Addendum 1

Project: BID NO. 9953 TROY SCHOOL DISTRICT 2023 PAVING PROGRAM

PROJECT: 2023 Troy School District Site Improvements – Paving Projects

PURPOSE: Addendum 1

PROJECT TITLE

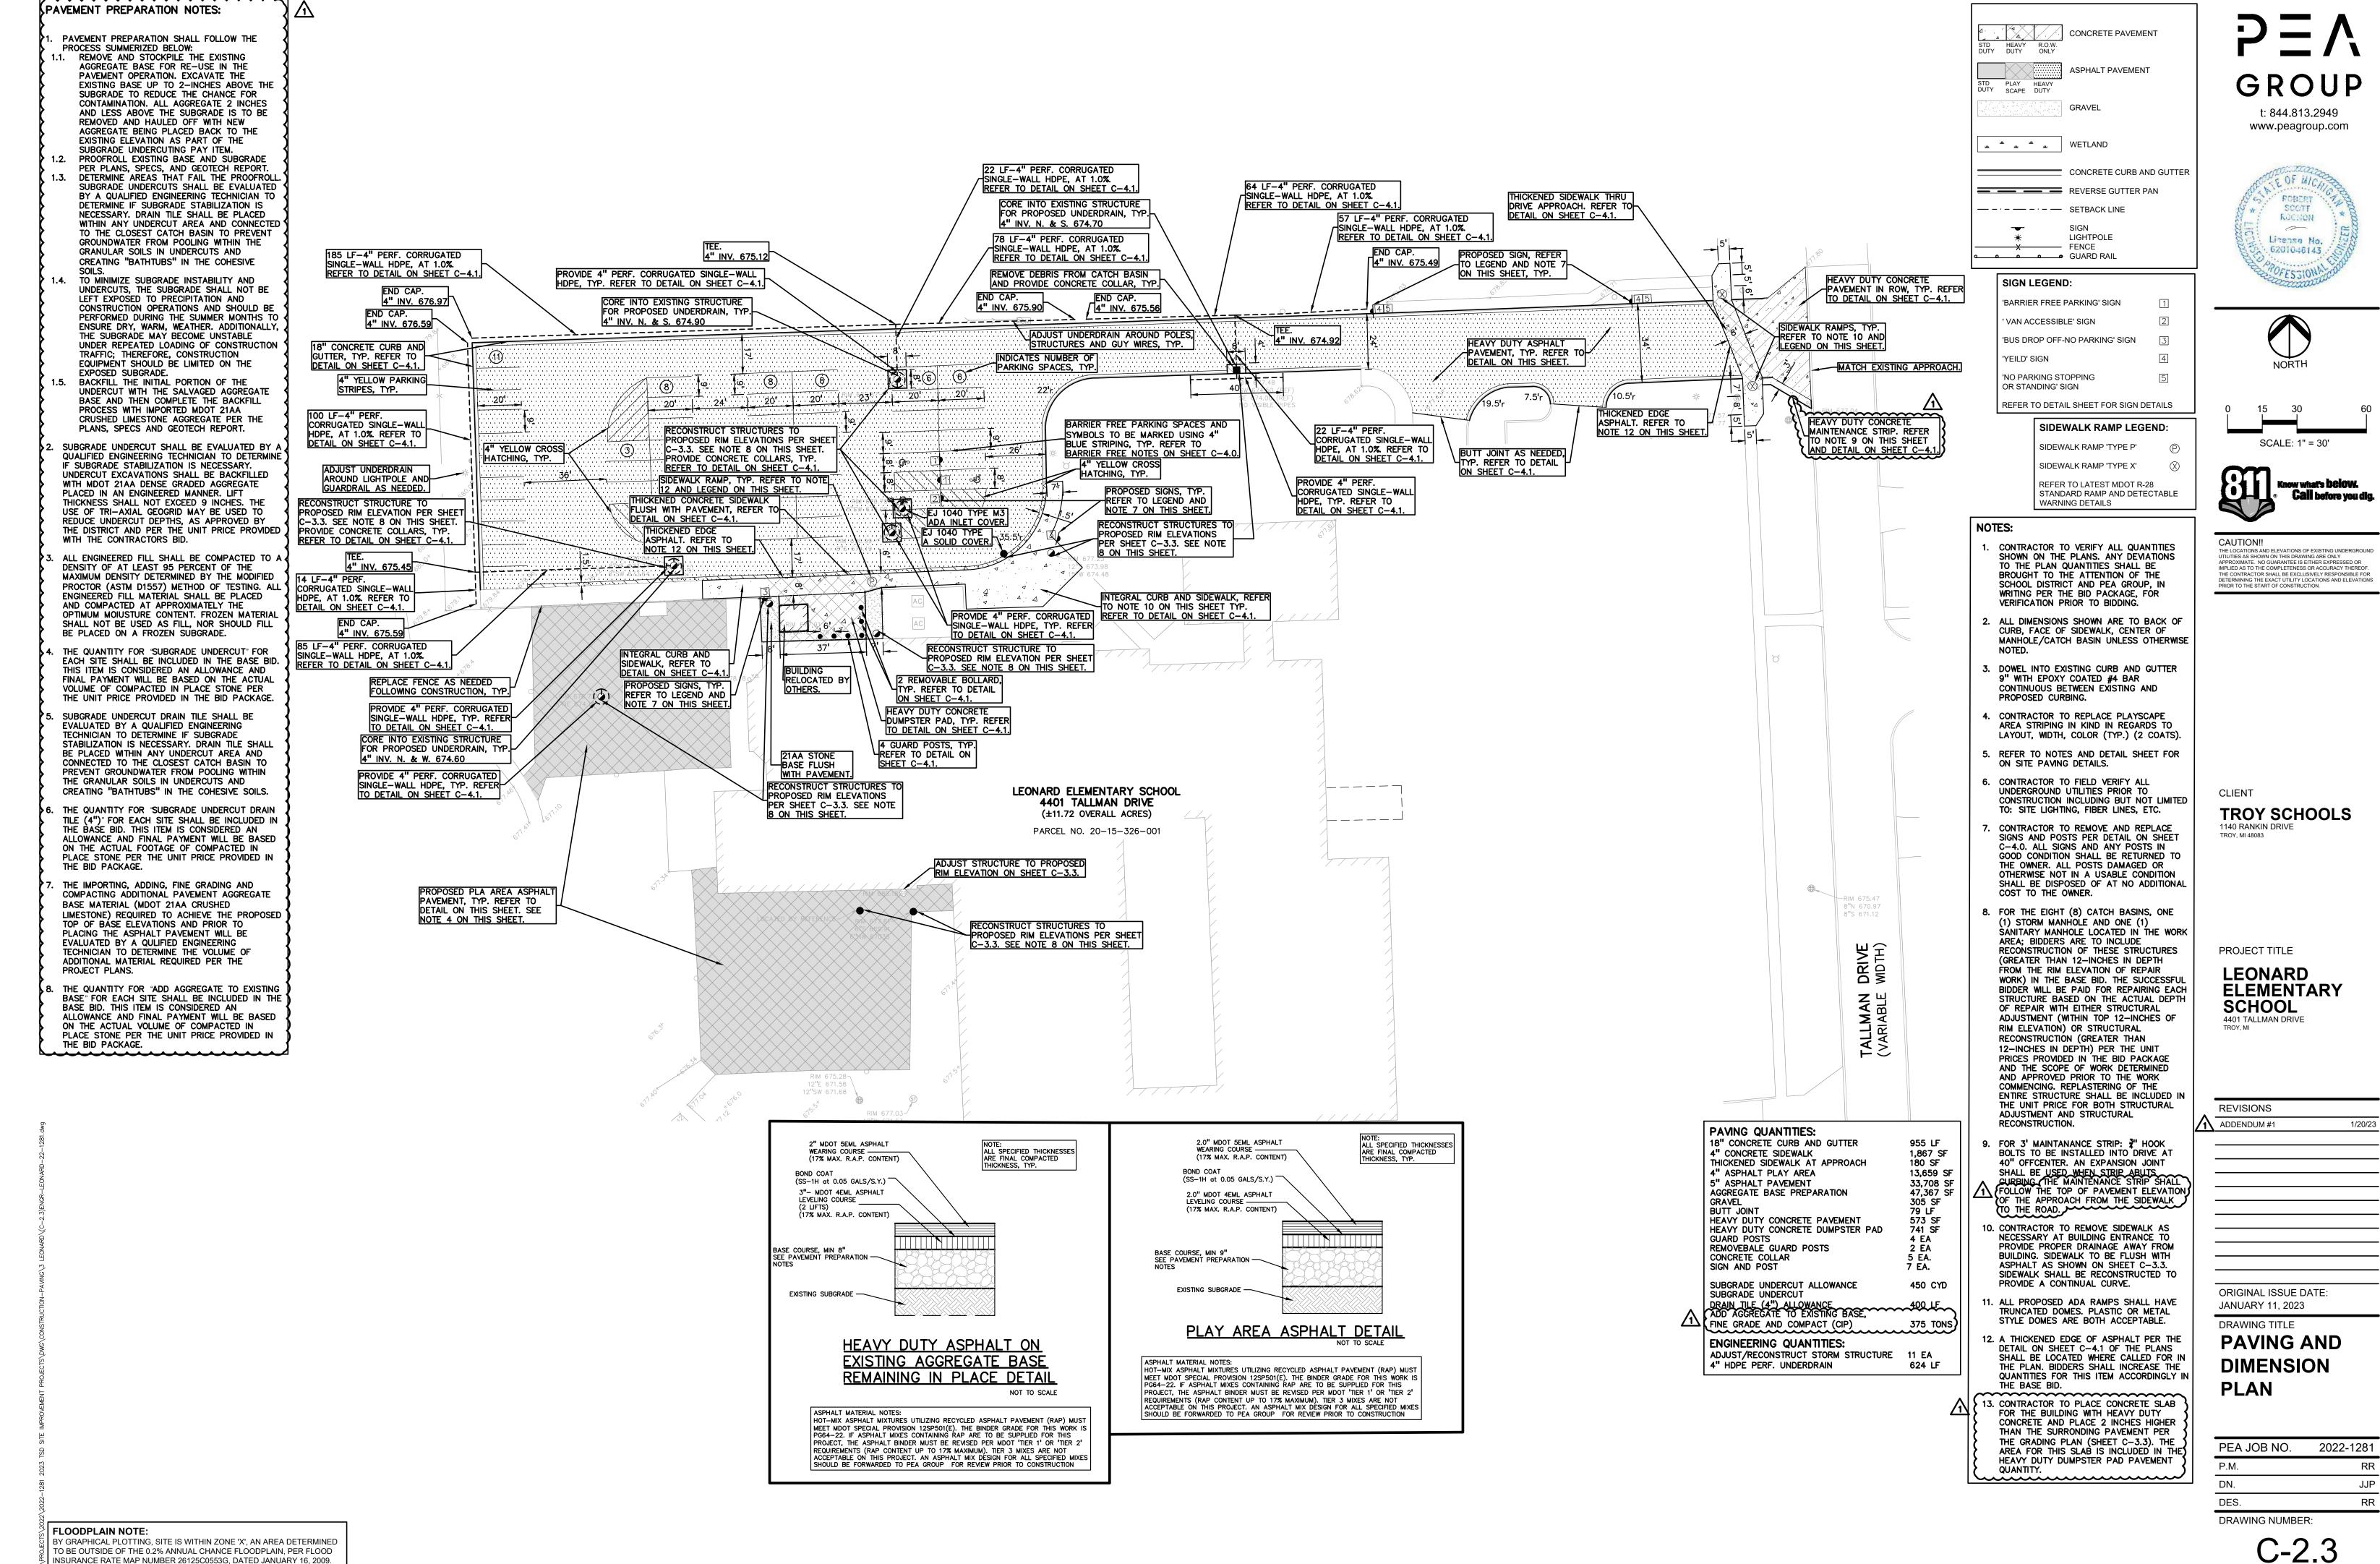
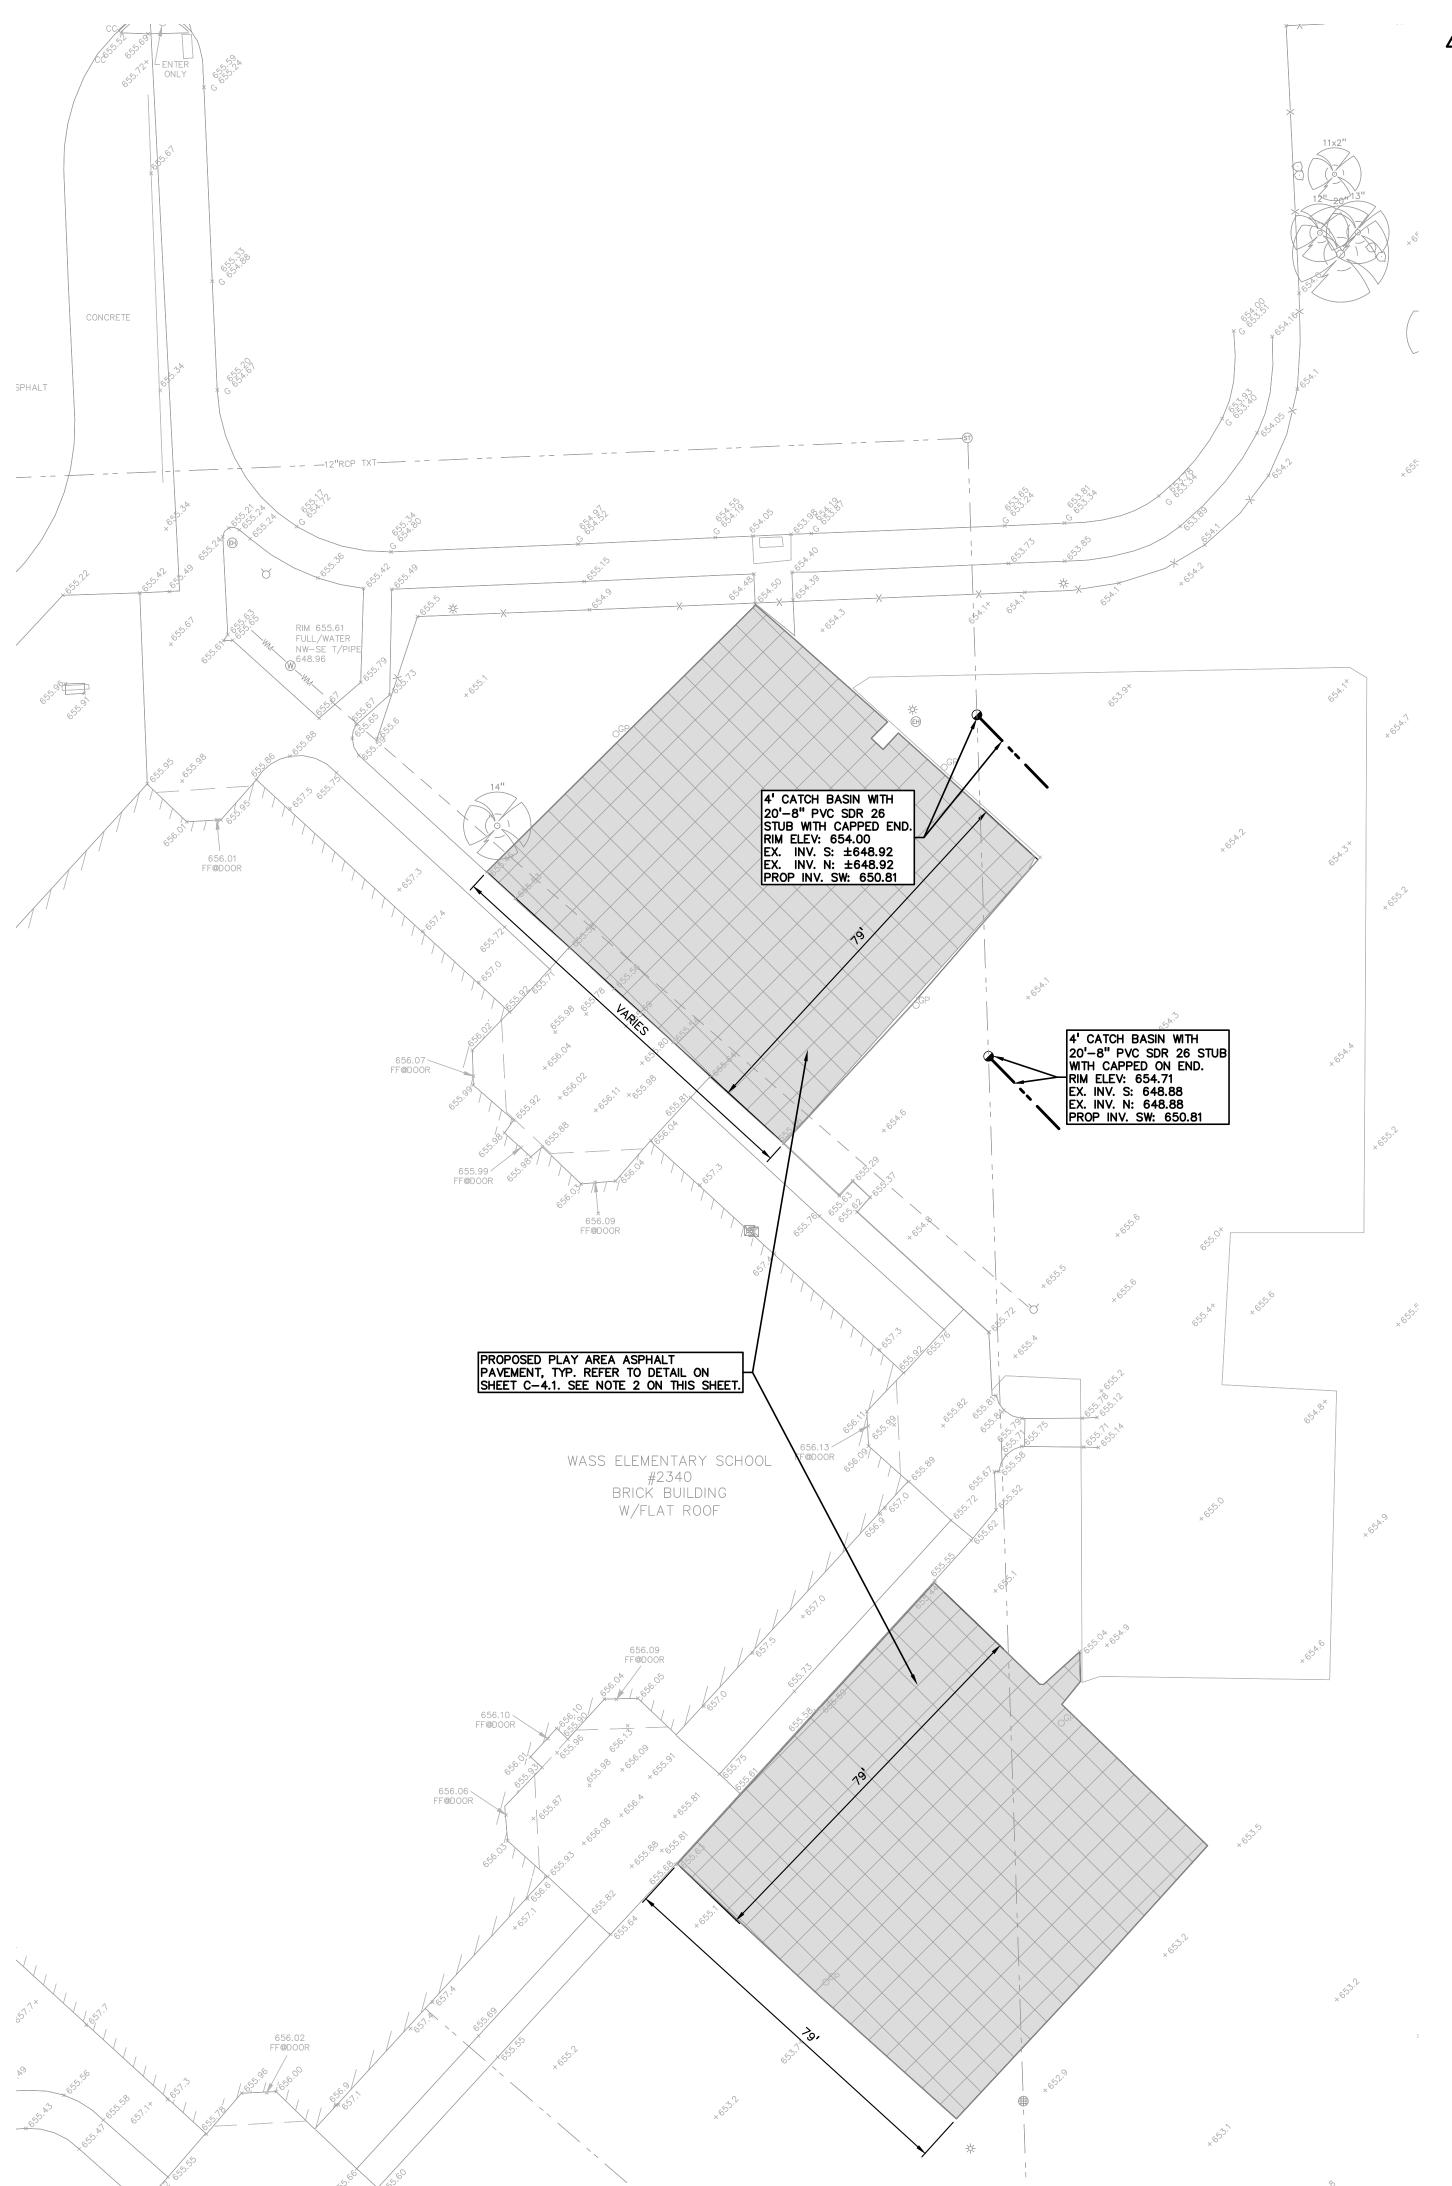
- a. Sheet C-2.4
 - Under "Notes" the note regarding the quantity for subgrade undercutting was deleted, was moved to the "Subgrade Undercutting Notes" and the notes were renumbered.
 - 2. The "Subgrade Undercutting Notes" were updated to provide additional clarification.

- TO MINIMIZE SUBGRADE INSTABILITY AND CONSTRUCTION TRAFFIC; THEREFORE,
- SUBGRADE UNDERCUT SHALL BE EVALUATED BY A QUALIFIED ENGINEERING TECHNICIAN TO DETERMINE IF SUBGRADE STABILIZATION IS NECESSARY. UNDERCUT EXCAVATIONS SHALL BE BACKFILLED WITH MDOT 21AA DENSE GRADED AGGREGATE PLACED IN AN ENGINEERED MANNER. LIFT THICKNESS SHALL NOT EXCEED 9 INCHES. THE USE OF TRI-AXIAL GEOGRID MAY BE USED TO REDUCE UNDERCUT DEPTHS, AS APPROVED BY
 THE DISTRICT AND PER THE UNIT PRICE PROVIDED

- UNDERCUTS, THE SUBGRADE SHALL NOT BE LEFT EXPOSED TO PRECIPITATION AND CONSTRUCTION OPERATIONS AND SHOULD BE PERFORMED DURING THE SUMMER MONTHS TO ENSURE DRY, WARM, WEATHER. ADDITIONALLY, THE SUBGRADE MAY BECOME UNSTABLE UNDER REPEATED LOADING OF CONSTRUCTION EQUIPMENT SHOULD BE LIMITED ON THE EXPOSED SUBGRADE.
- WITH THE CONTRACTORS BID.
- THE QUANTITY FOR "SUBGRADE UNDERCUT" FOR EACH SITE SHALL BE INCLUDED IN THE BASE BID.
 THIS ITEM IS CONSIDERED AN ALLOWANCE AND FINAL PAYMENT WILL BE BASED ON THE ACTUAL VOLUME OF COMPACTED IN PLACE STONE PER THE UNIT PRICE PROVIDED IN THE BID PACKAGE.
- PLACED ON A FROZEN SUBGRADE.
- EVALUATED BY A QUALIFIED ENGINEERING TECHNICIAN TO DETERMINE IF SUBGRADE STABILIZATION IS NECESSARY. DRAIN TILE SHALL CREATING "BATHTUBS" IN THE COHESIVE SOILS.

TRANSPORTATION CENTER

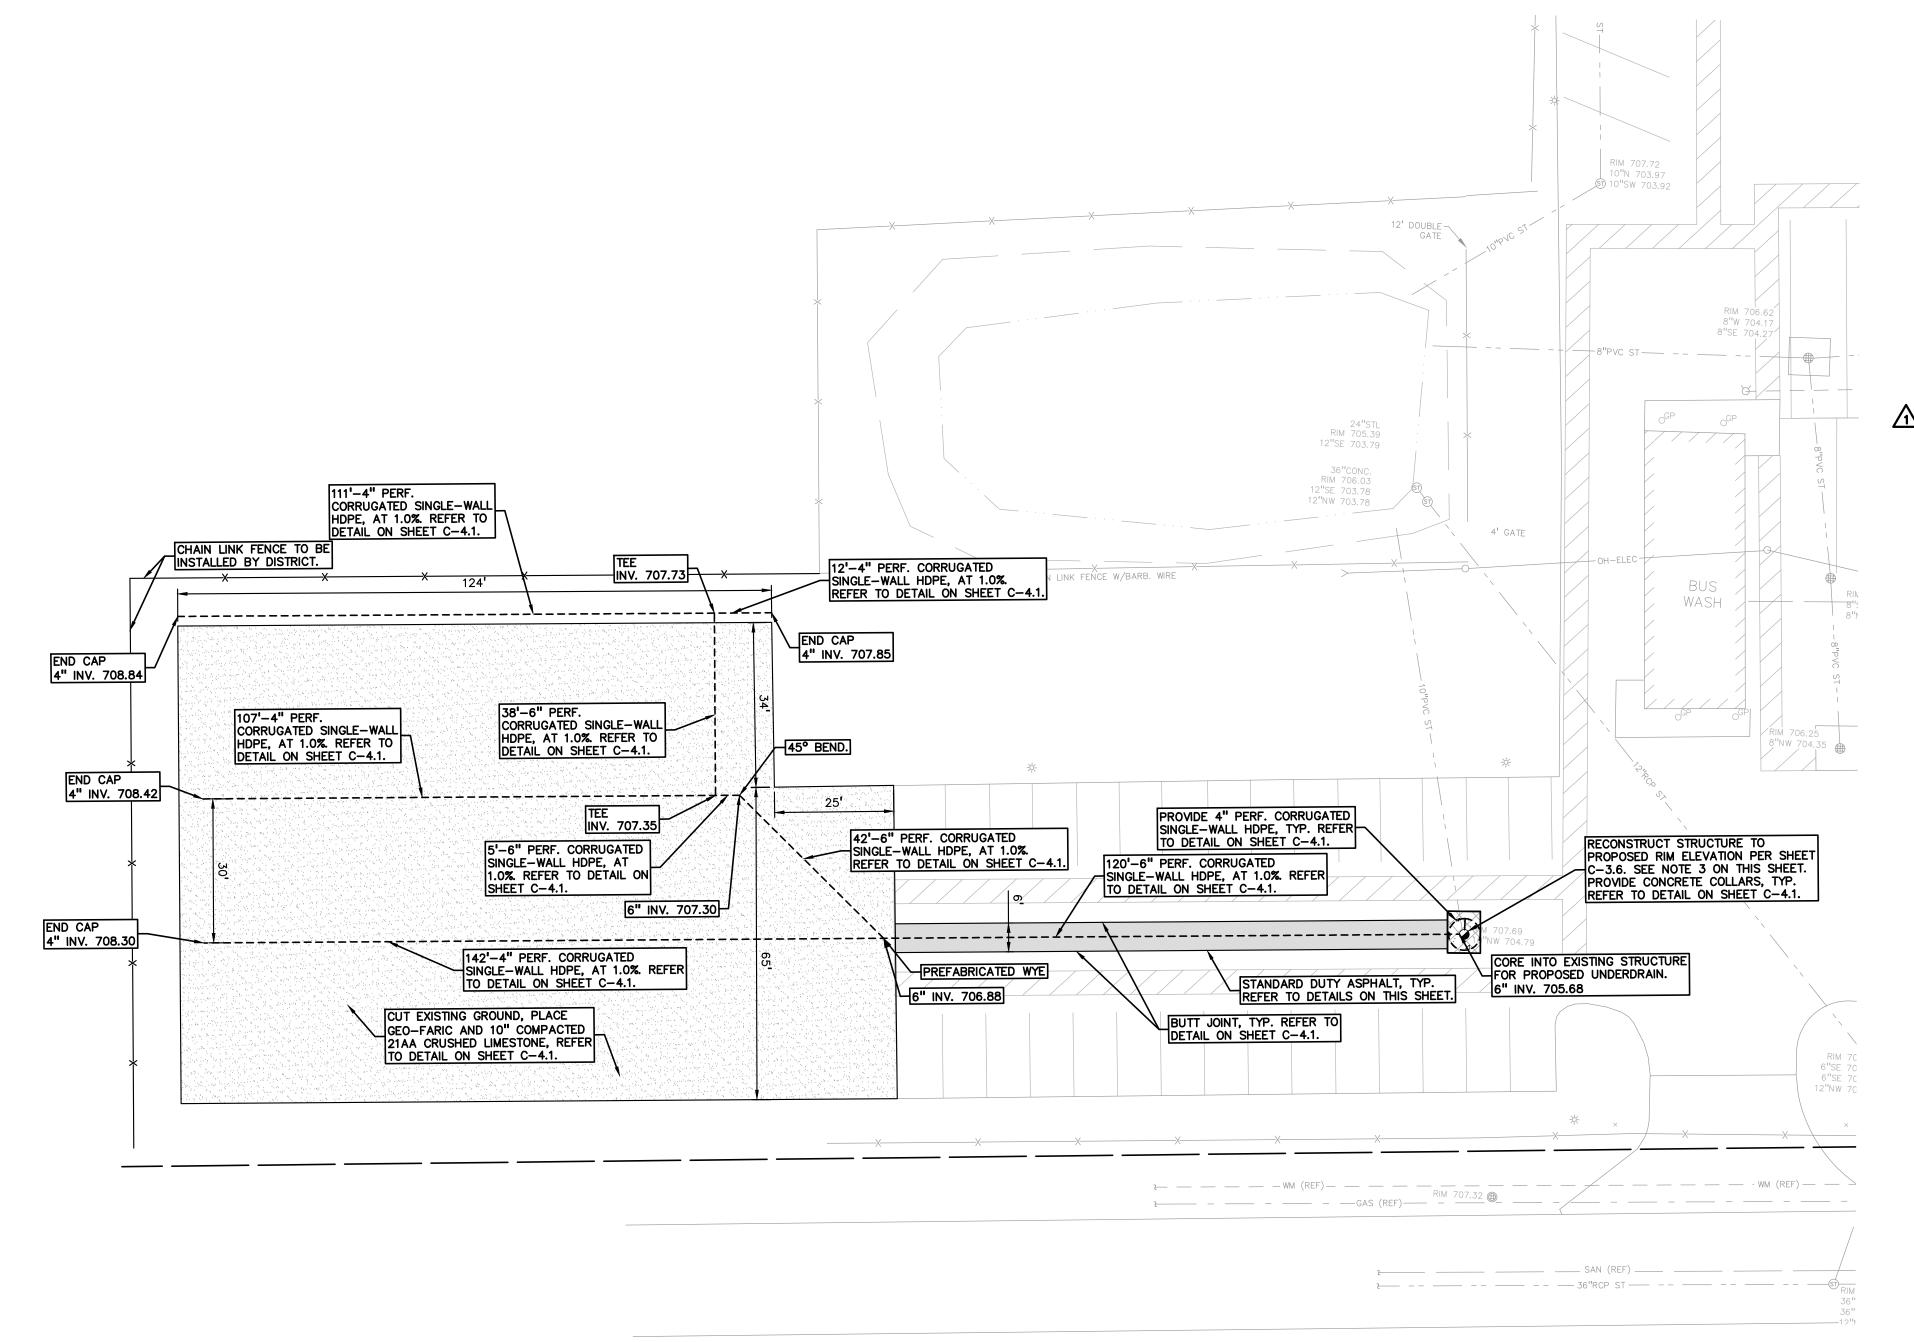
- a. Sheet C-2.6
 - 1. The "Subgrade Undercutting Notes" were updated to provide additional clarification.

SUBGRADE UNDERCUTTING NOTES:

TO MINIMIZE SUBGRADE INSTABILITY AND UNDERCUTS, THE SUBGRADE SHALL NOT BE LEFT EXPOSED TO PRECIPITATION AND CONSTRUCTION OPERATIONS AND SHOULD BE PERFORMED DURING THE SUMMER MONTHS TO ENSURE DRY, WARM, WEATHER. ADDITIONALLY. THE SUBGRADE MAY COME UNSTABLE UNDER REPEATED LOADING OF CONSTRUCTION TRAFFIC; THEREFORE,
CONSTRUCTION EQUIPMENT SHOULD BE LIMITED ON THE EXPOSED SUBGRADE.

SUBGRADE UNDERCUT SHALL BE EVALUATED BY A QUALIFIED ENGINEERING TECHNICIAN TO DETERMINE IF SUBGRADE STABILIZATION IS NECESSARY. UNDERCUT EXCAVATIONS SHALL BE BACKFILLED WITH MDOT 21AA DENSE GRADED AGGREGATE PLACED IN AN ENGINEERED MANNER. LIFT THICKNESS SHALL NOT EXCEED 9 INCHES. THE USE OF TRI-AXIAL GEOGRID MAY BE USED TO REDUCE UNDERCUT DEPTHS, AS APPROVED BY THE DISTRICT AND PER THE UNIT PRICE PROVIDED WITH THE CONTRACTORS BID.

THE QUANTITY FOR "SUBGRADE UNDERCUT" FOR EACH SITE SHALL BE INCLUDED IN THE BASE BID. THIS ITEM IS CONSIDERED AN ALLOWANCE AND FINAL PAYMENT WILL BE BASED ON THE ACTUAL FOOTAGE OF COMPACTED IN PLACE STONE PER

THE UNIT PRICE PROVIDED IN THE BID PACKAGE. ALL ENGINEERED FILL SHALL BE COMPACTED TO A DENSITY OF AT LEAST 95 PERCENT OF THE MAXIMUM DENSITY DETERMINED BY THE MODIFIED PROCTOR (ASTM D1557) METHOD OF TESTING. ALL ENGINEERED FILL MATERIAL SHALL BE PLACED AND COMPACTED AT APPROXIMATELY THE OPTIMUM MOIUSTURE CONTENT. FROZEN MATERIAL SHALL NOT BE USED AS FILL, NOR SHOULD FILL BE PLACED ON A FROZEN SUBGRADE.
